May 26, 2017

TO : All Bidders
FROM : George M. Wiens
PROJECT : CTE Classroom Addition
1615400.41
SUBJECT : Addendum 1
DSA : 04-115755 / 33-H18

1/4" = 1'-0" 11

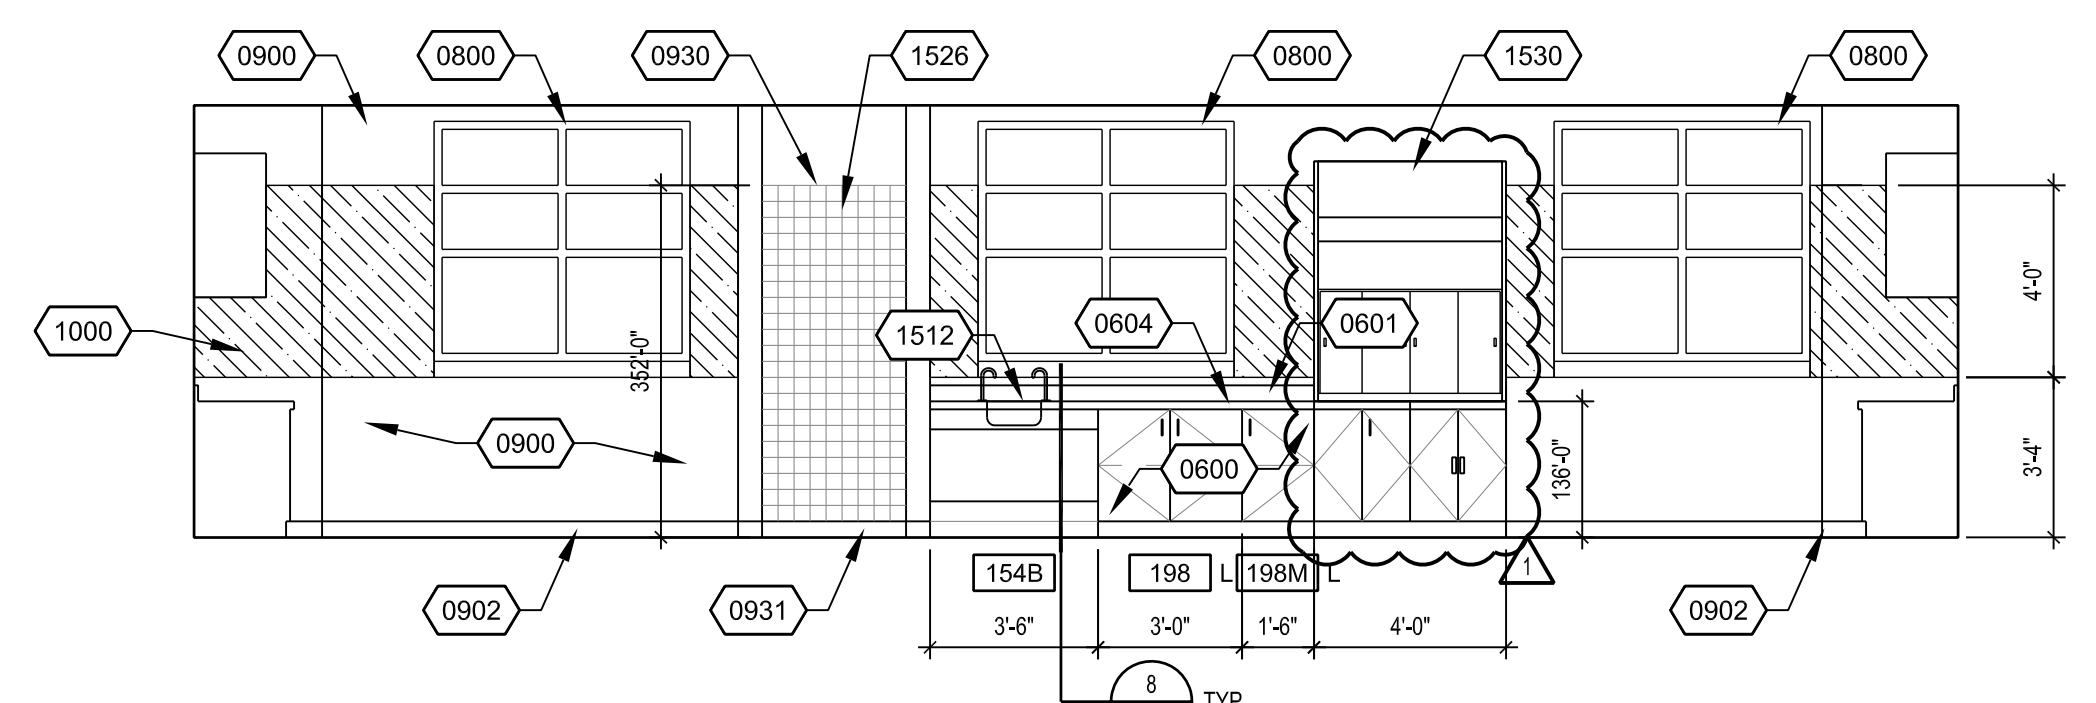
- A. Revise as indicated in the clouded area labeled Delta 1 on the attached AW3.2.

DRAWING NUMBER: **SW2.1**

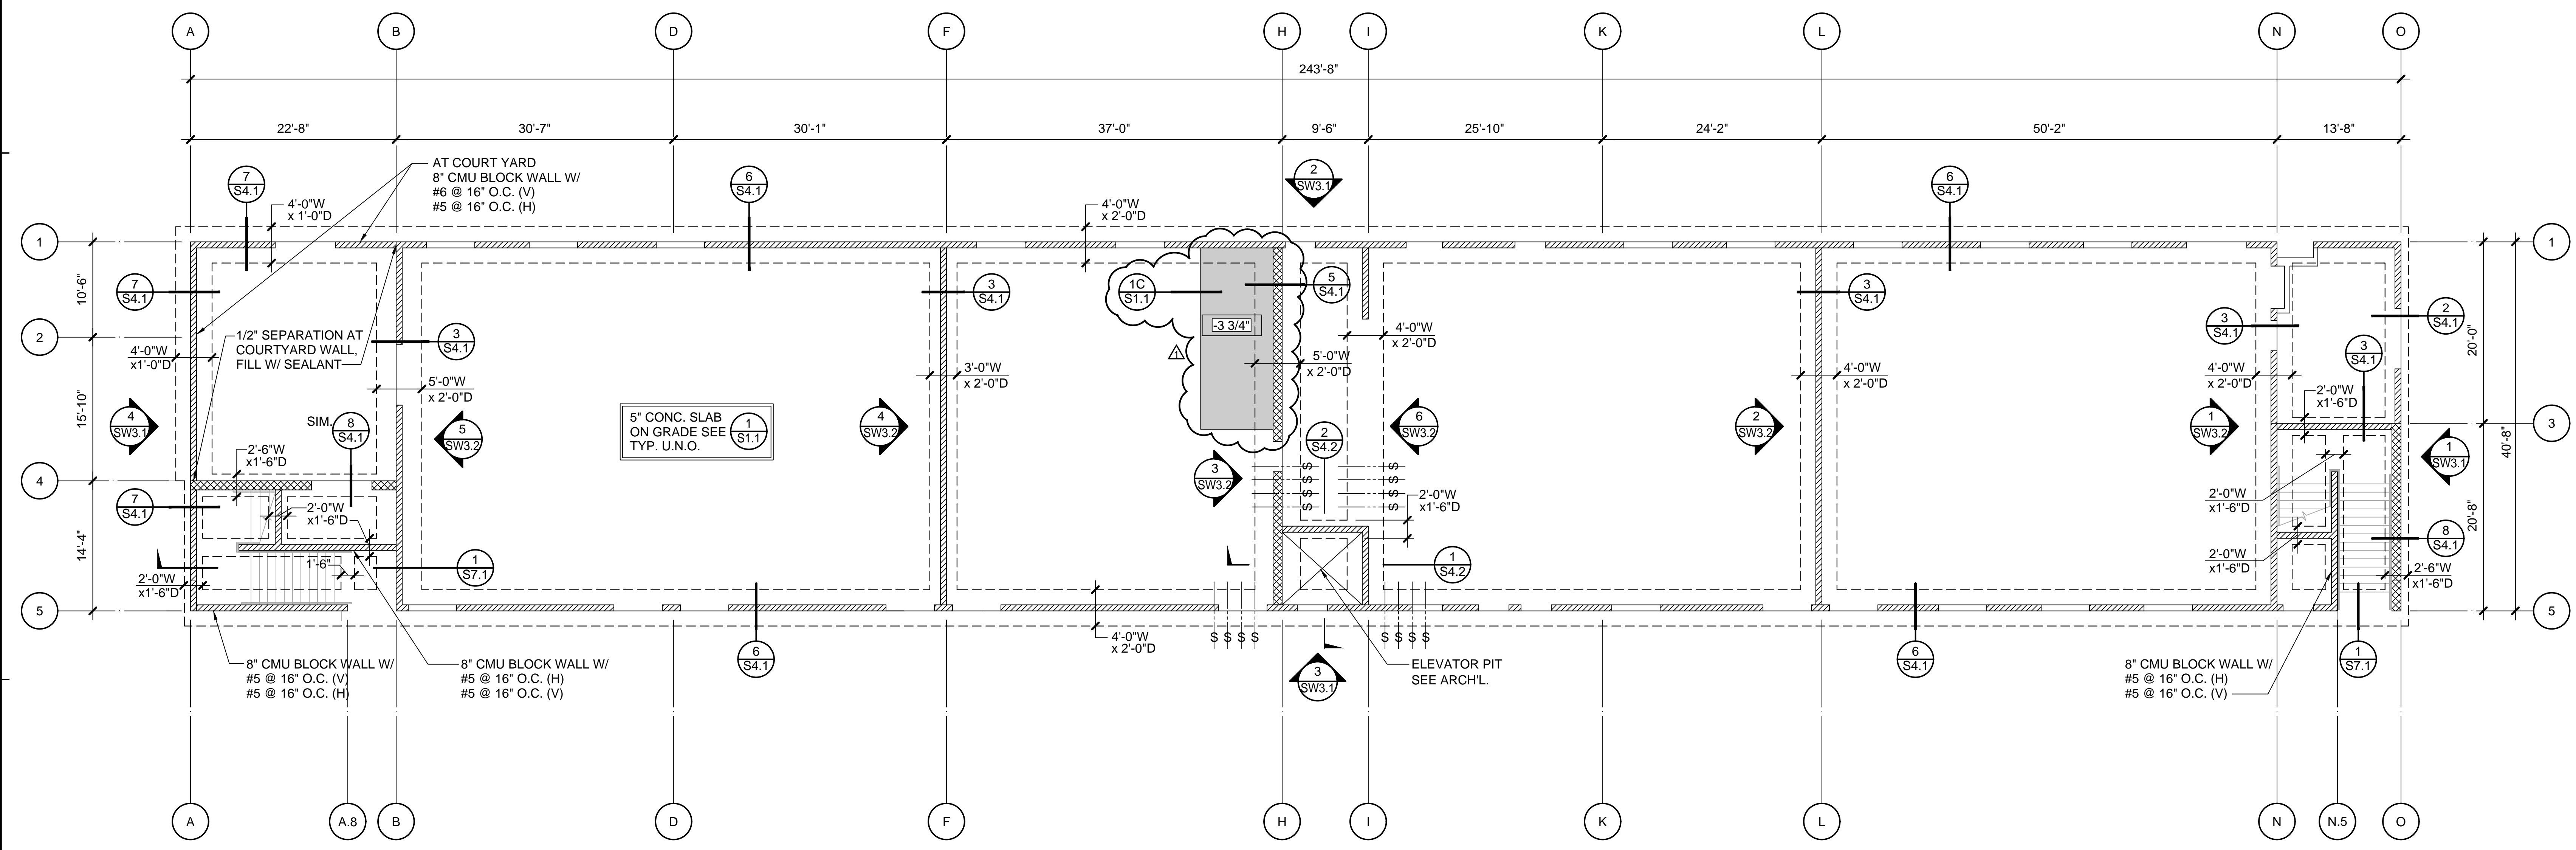
- A. Revise as indicated in the clouded area labeled Delta 1 on the attached SW2.1.
